Product Change Notification

1. ECN #: 242874

- ZF5S - ZERO INSERTION FORCE .5MM ASSEMBLY

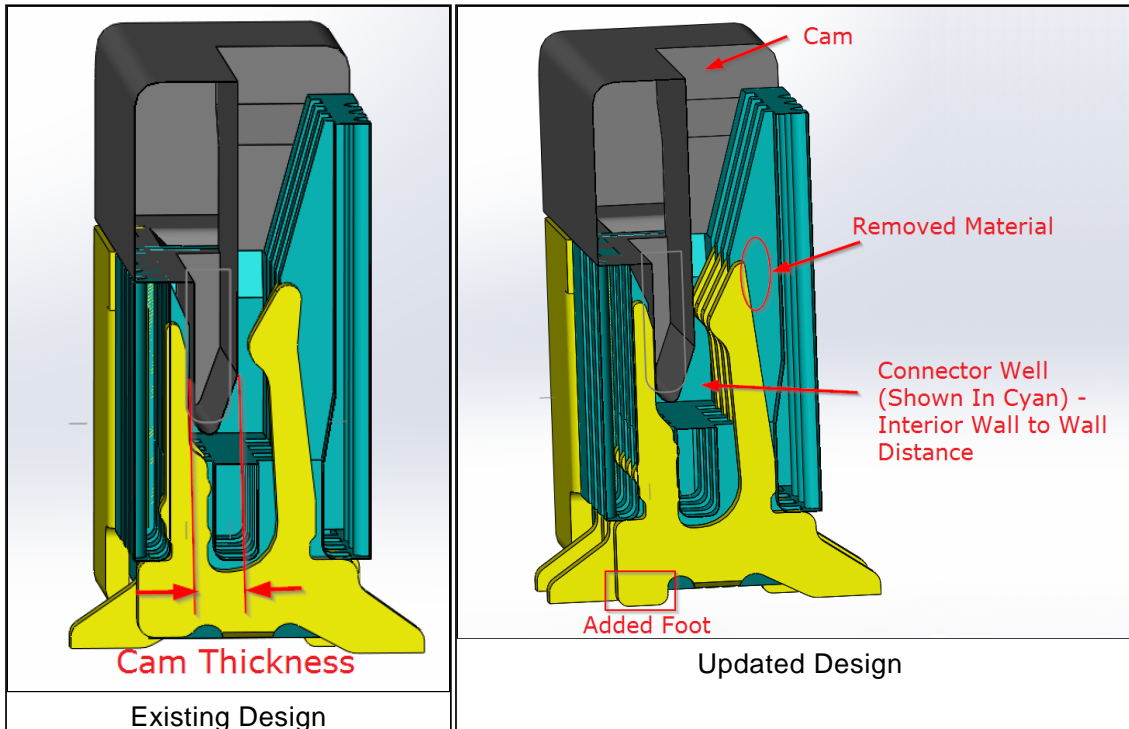
Force to close cam may increase by 18% on highest pin count connectors. A processing "foot" will now be present on -03 lead styles.

Removed tip material, decreased well opening by 0.18mm, reduced cam thickness variation from 0.27-0.40mm to 0.33-0.38mm, added "foot" to the -03 lead style contacts

Product improvements to increase service life of product, improve flex registration, decrease processing distortion (during reflow to printed circuit board it was possible for the connector to take on a concave shape)

- Function - higher mate force

- Form - addition of visible "foot" to contacts
